**Land south of the A271 and east of the A22,
Lower Horsebridge, Hailsham, East Sussex,
BN27 4DN**

**Transport and Highways Statement of Common Ground between the Appellant
and East Sussex County Council.**

Planning Inspectorate Ref. APP/C1435/W/23/3335625

Report Title: Statement of Common Ground on Transportation

Attachment 2: Proposed Shared Walking and Cycling path and Bus Stops

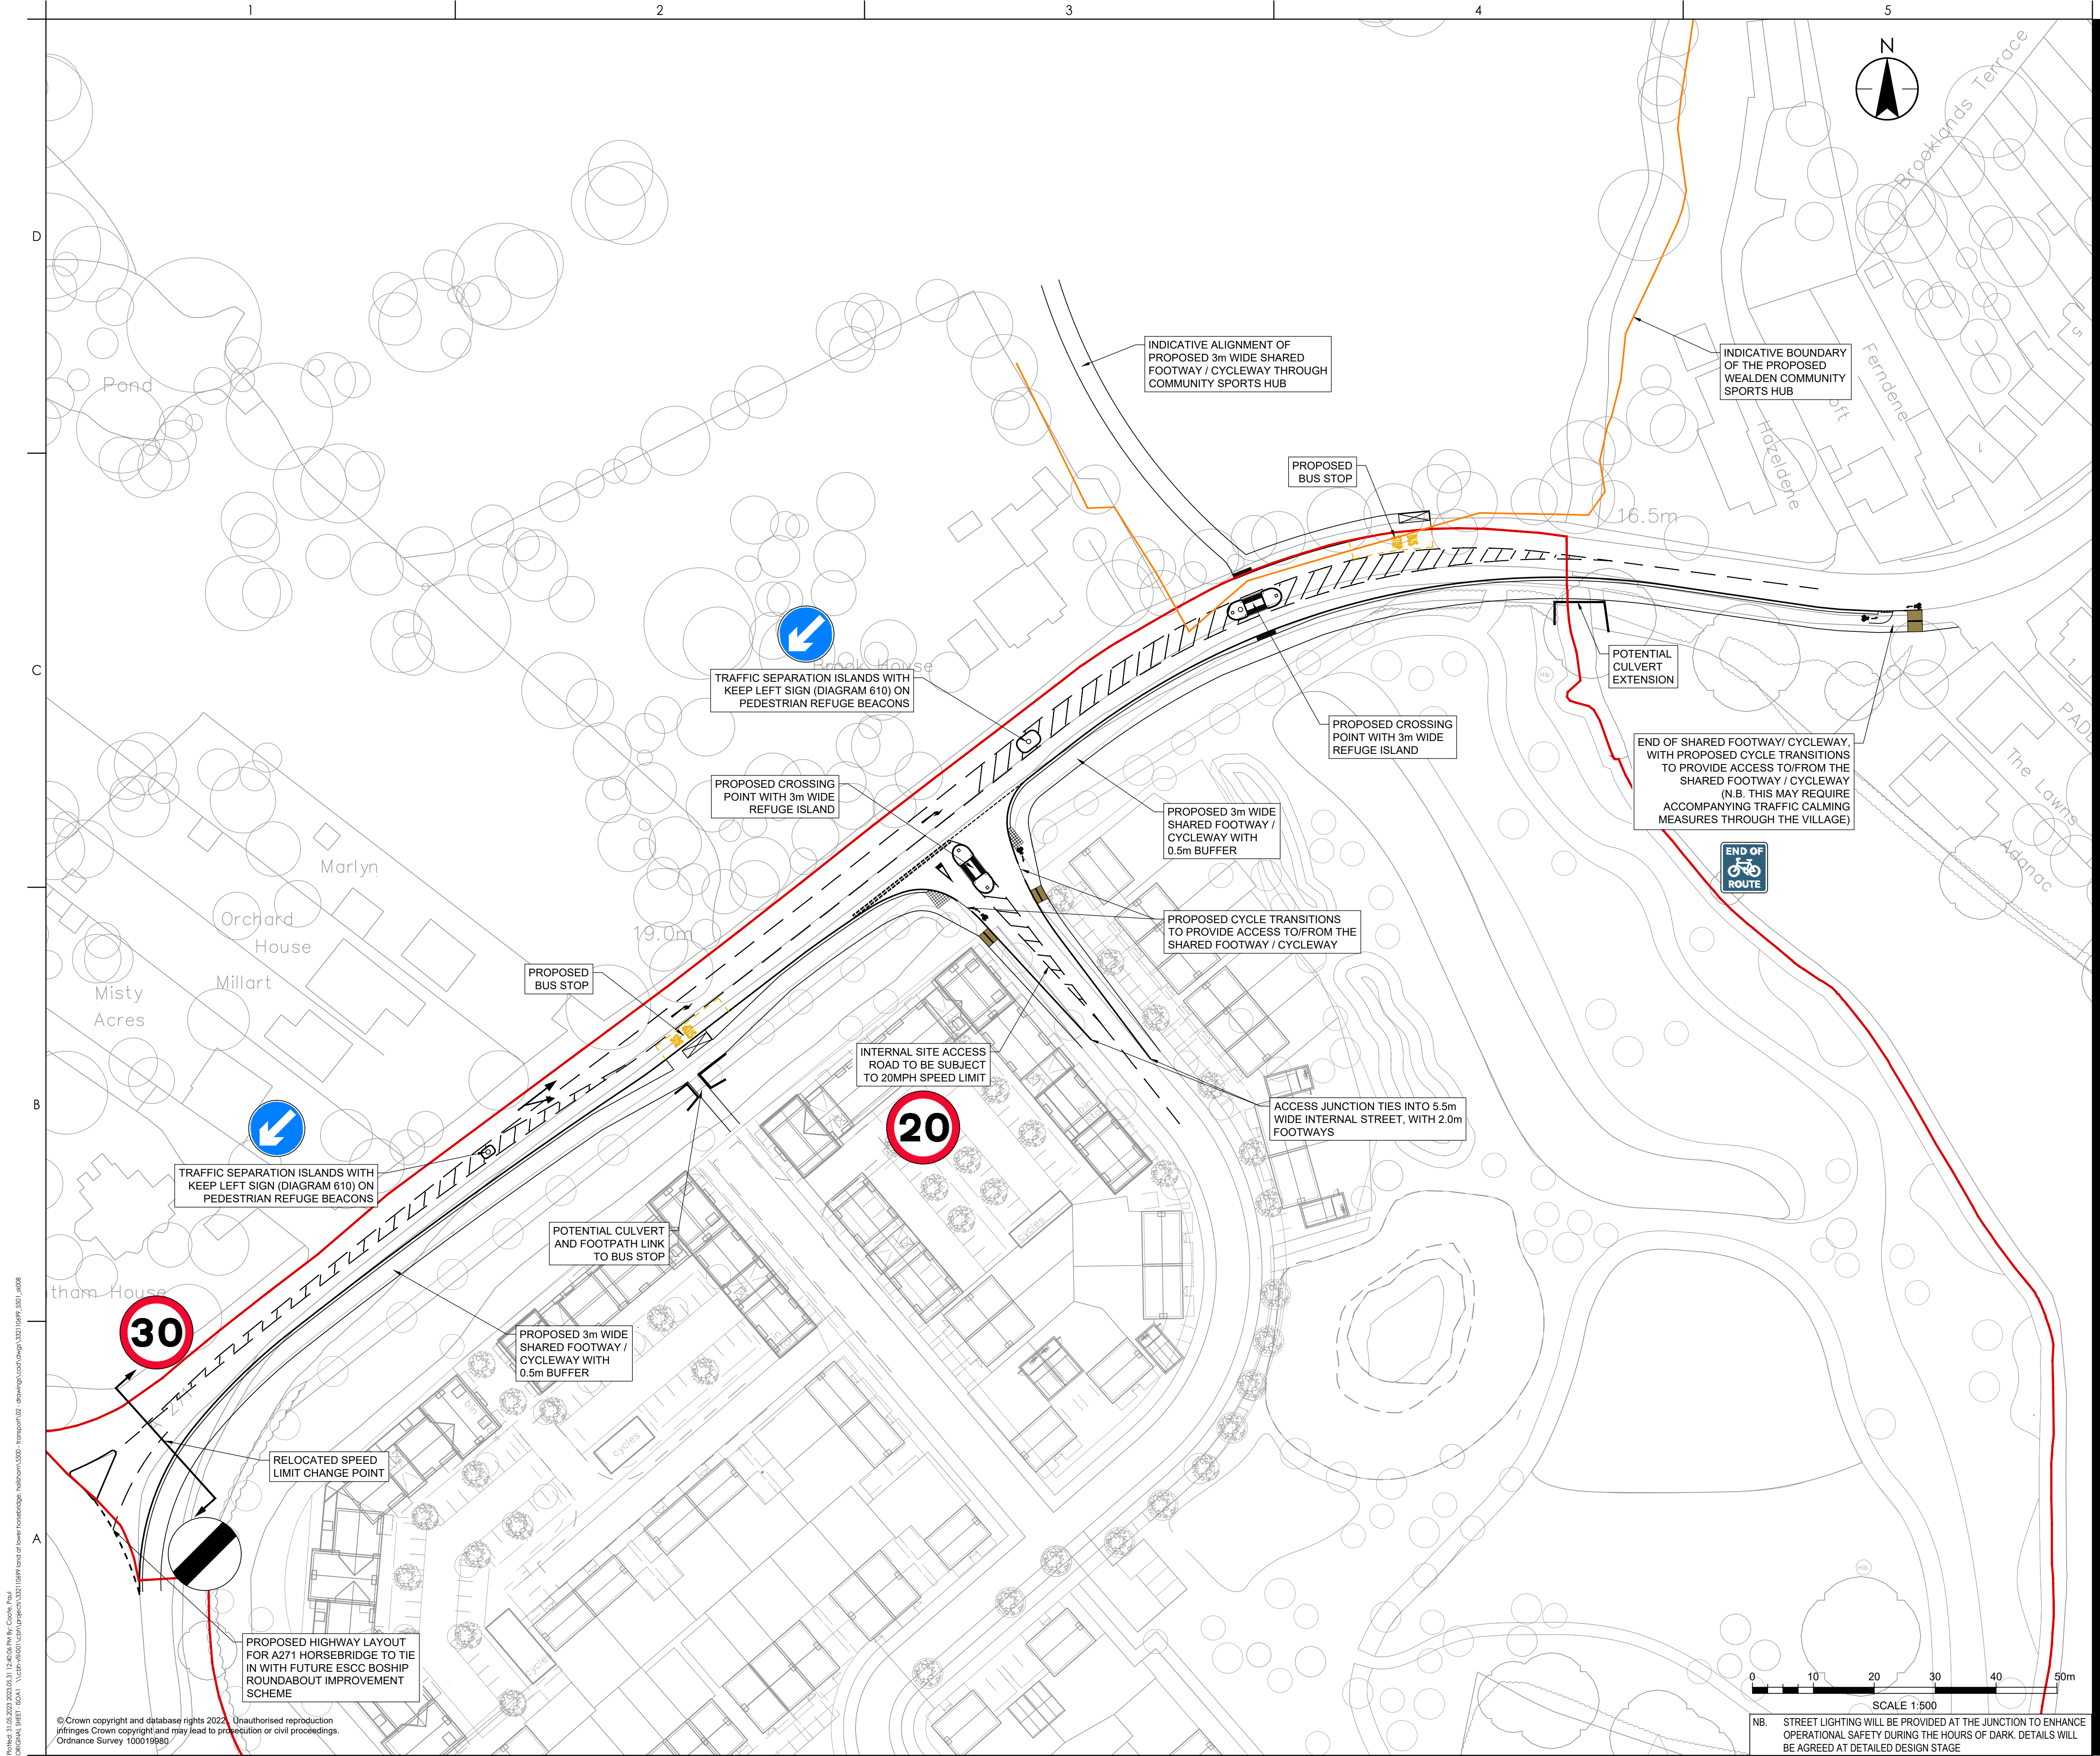
- *A Non-Motorised User Audit has not been submitted with the application to detail the current availability and standard of non-car travel routes for resident. The TA doesn't include an assessment of the quality of those routes.*
- *No footway improvements to [Hellingly primary] school- or anywhere else, are proposed as part of the development only a footway along the site frontage and pedestrian refuge islands as part of the new access arrangement – a Right Turn Lane. The necessary associated tactile paved dropped crossing points are not shown on plans no: 332110699_5501_SK001 rev P03.*
- *...It is disappointing that [footway] improvements are not proposed [along B2014 North Street]*

It is proposed that a 3m shared walking and cycling path is provided along the site frontage on the A271 Lower Horsebridge (Refer to **Attachment 2**). This would provide a cycling facility segregated from vehicle traffic and in accordance with Hailsham's LCWIP, as explained under Paragraph 3.3 below. Additionally, this would significantly improve a key section of the walking and cycling route to the Cuckoo trail which is currently in a very poor standard. As set out in **Attachment 3**, there is potential for wider improvements to the walking and cycling route to the Cuckoo trail. However, it is beyond the remit of the developer to deliver or fully fund off-site improvements not within close proximity to the site

Figure 1: Proposed Layout of Boship Roundabout Improvement (part of A22 Improvement Study)

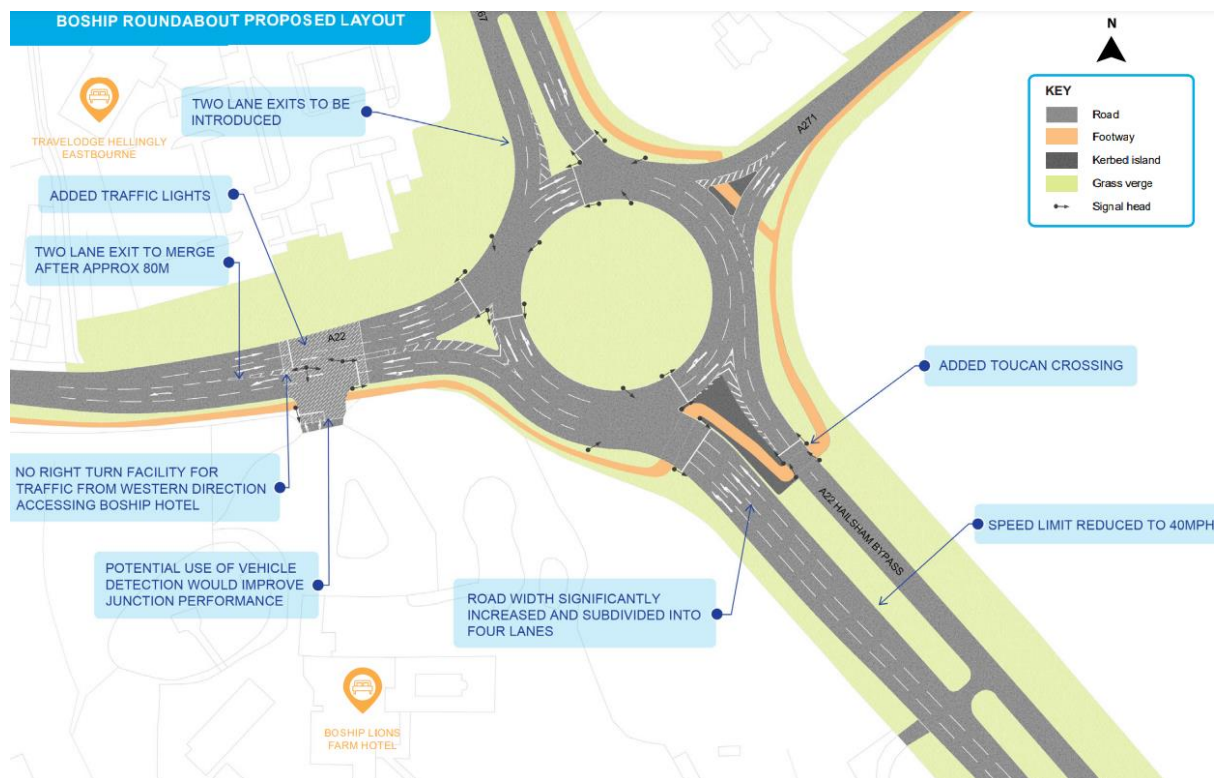
The proposed design is shown in Figure 1 earlier; traffic signals have been suggested for the roundabout approaches at the A22 south, A22 west and A267 (northern approach). It is envisaged that the northern arm of the roundabout would also require widening to accommodate a longer two-lane approach and to provide the required storage capacity. The existing priority-controlled approach to the roundabout from the A271 would be retained and widened to include an additional flared entry lane. On the A22 west, the existing single lane carriageway with two entry lanes would be improved to provide two lanes plus a flare. Additionally, the A22 west exit would be modified to allow a two-lane exit which would merge into one lane downstream of the existing hotel access. With the widening of the carriageway, the existing two-lane southern arm approach would be widened to accommodate two additional flared lanes.
